Re: EQT Production Company- OXF 157 Proposed Well Pad, Associated Pit, and Access Road Modification

**OXF 157 Well Pad, Pit and Access Road Modification**

**Purpose of development: Well Pad, Associated Pit and Access Road Modification**

**Stream Crossing "D" Details**

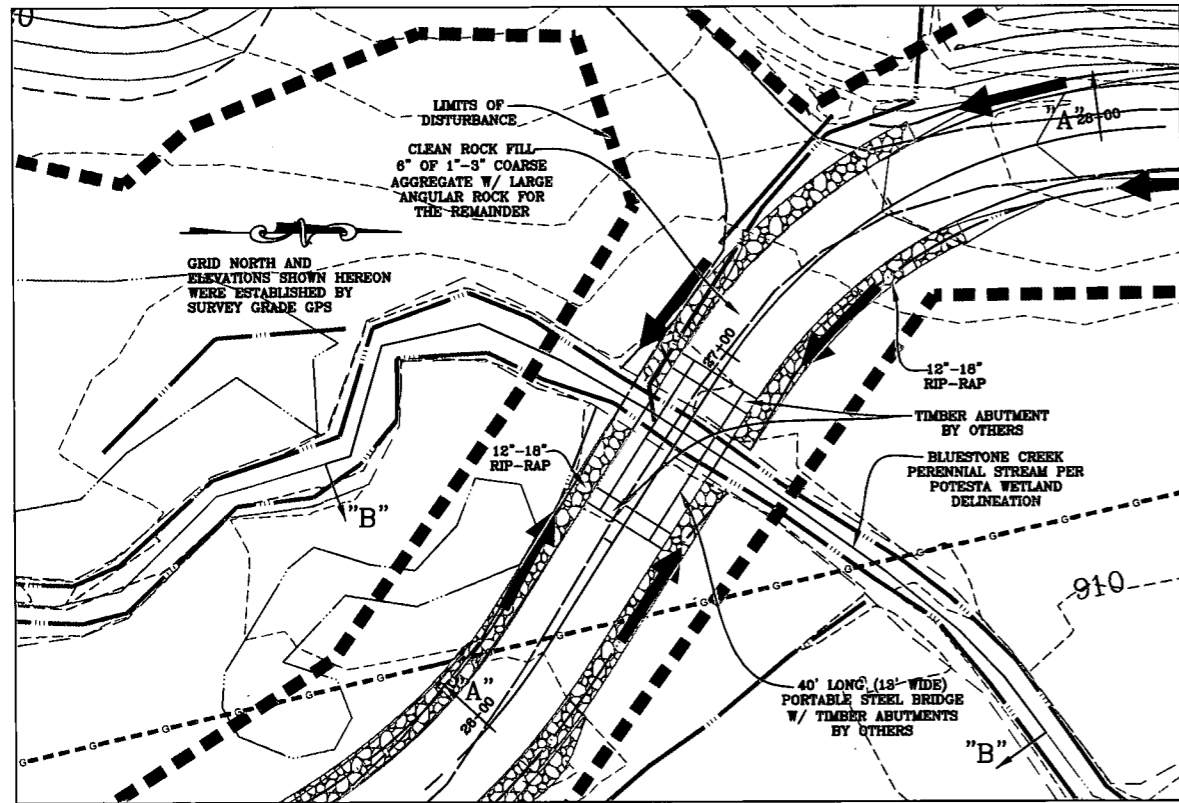
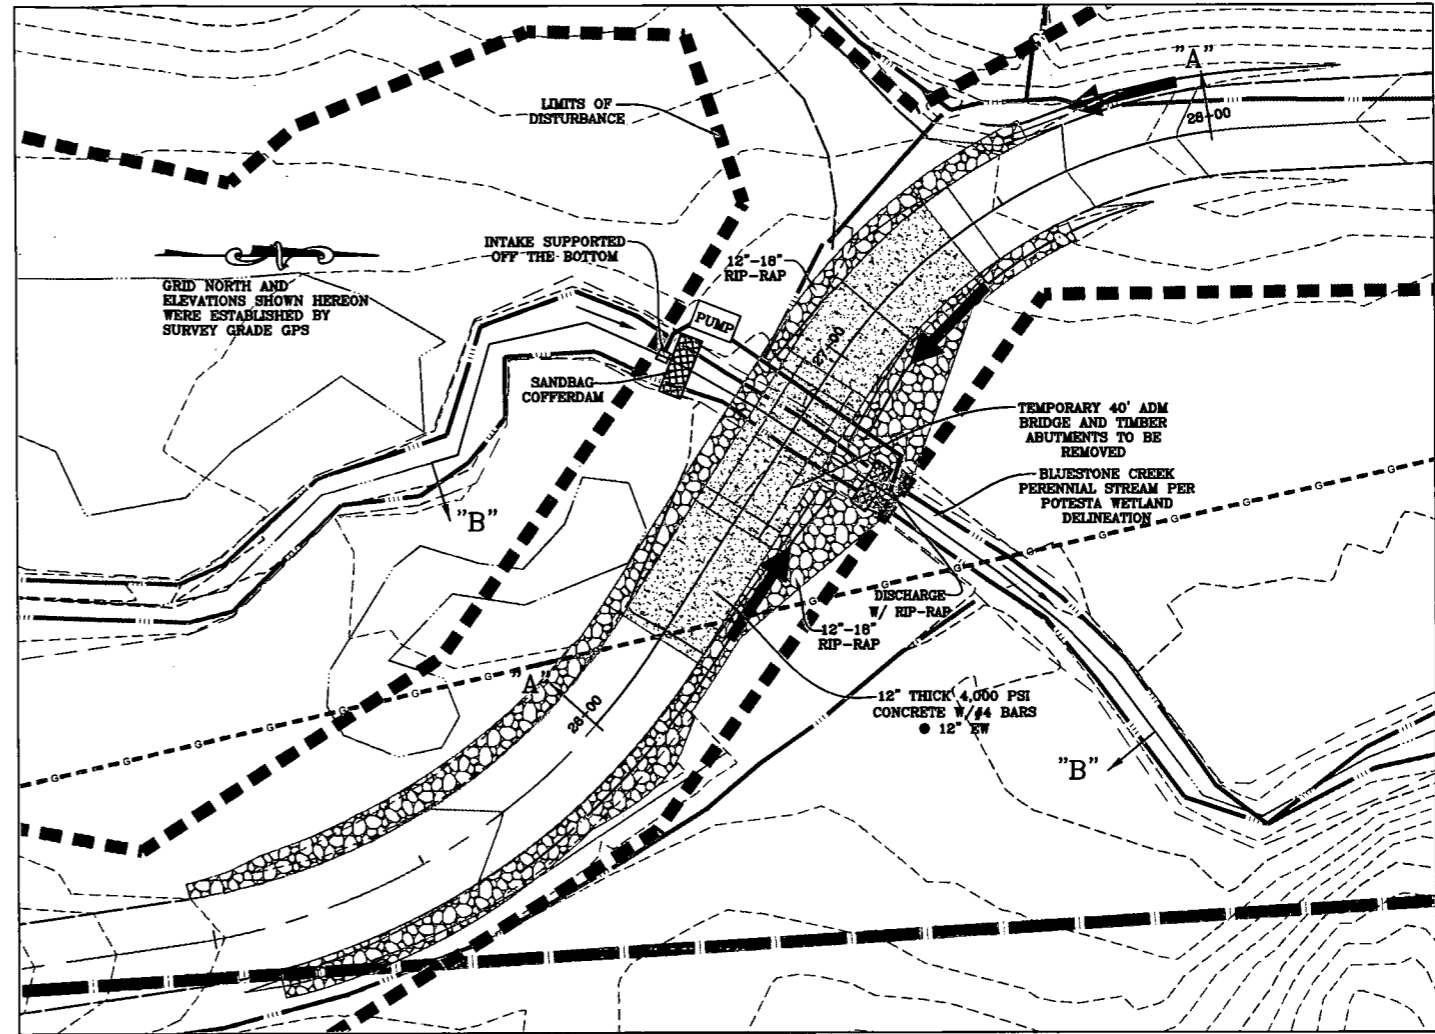
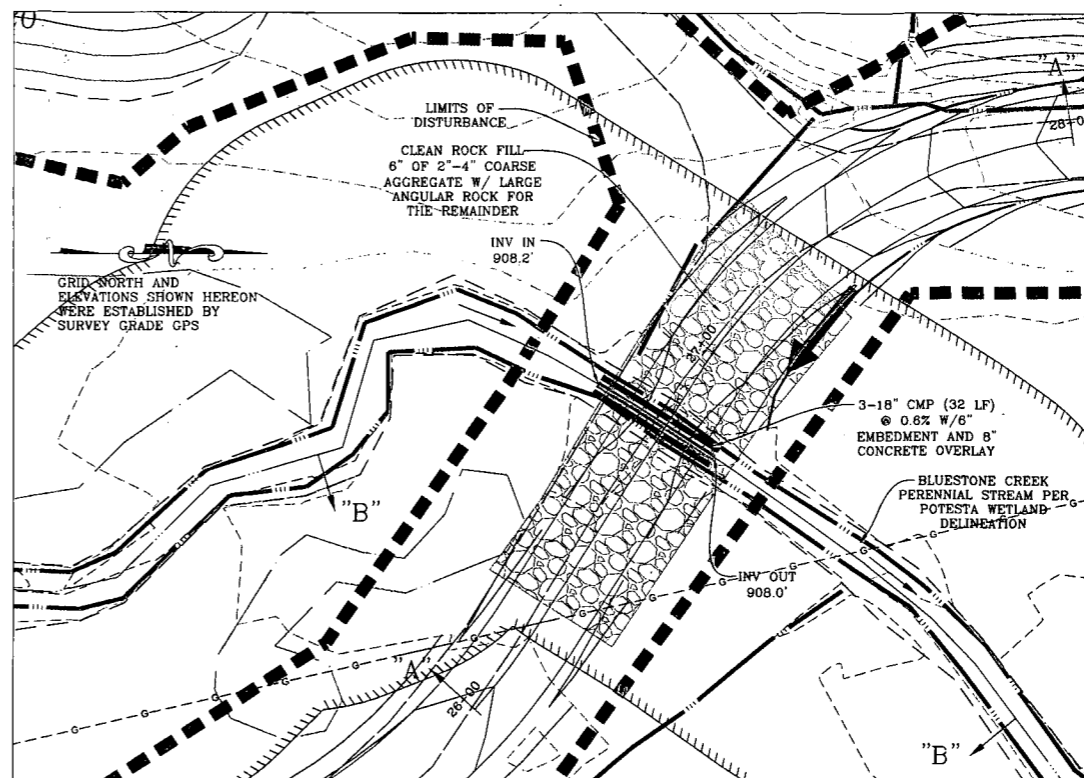
### **Stream Crossing D (Sheet 24 of Site Plans Revised 6/03/2014)**

- **Permanent Crossing:**
  - The original design (Sheet 24 of Original Site Plans dated 11/04/2013) had a proposed permanent crossing with (3) 18” CMP culverts.
  - The revised design shows the permanent crossing where the temporary bridge will be removed and a concrete low water ford crossing will be constructed. This low water ford will be comprised of 12” thick 4,000 PSI concrete reinforced with #4 rebar 12” each way and will have 12”-18” of rip rap. During construction, a sandbag cofferdam will be placed on the inlet and outlet sides of the stream crossing. The water will then be pumped around while the low water crossing is being constructed.
